AJ Fashions Ltd

234/4, Kachukhet, Cantonment, Dhaka-126
(23.795079N 90.388263E)

7 May 2014

Observations

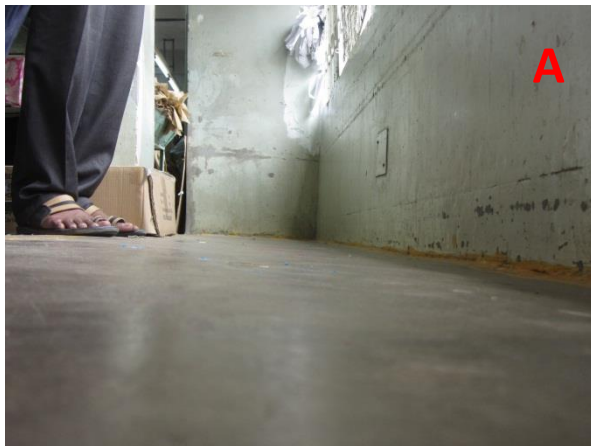
**Cantilever slab at edges of 1st & 2nd floor has
large deflections**

ITEM 2 - Sagging slab edge cantilevers at first and second floors.

Deflection of slab edges

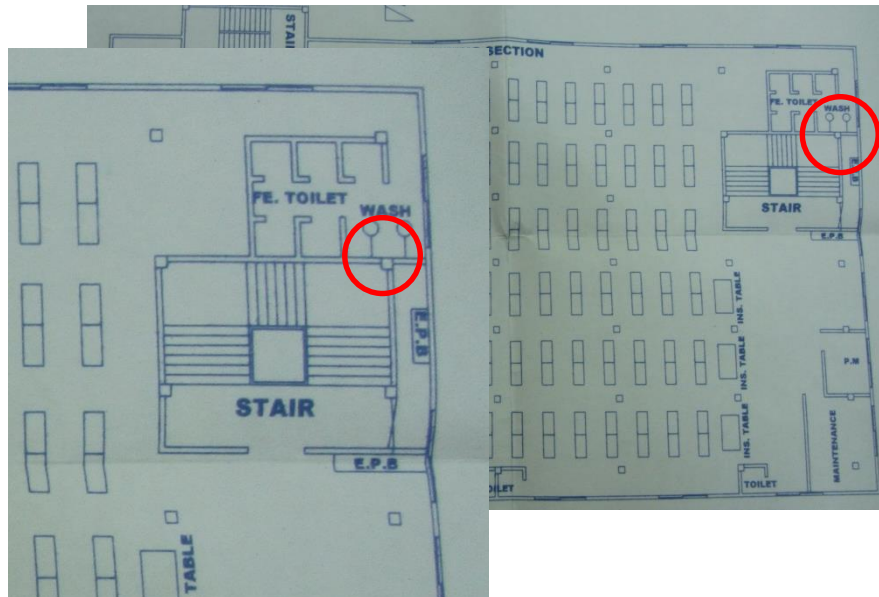
35mm deflection of slab edges at 1st and 2nd floor (photos A-C) with consistent cracking in floor finishes (D) and facades (E). No noticeable deflection at upper levels which are supported by cantilevering beam (F).
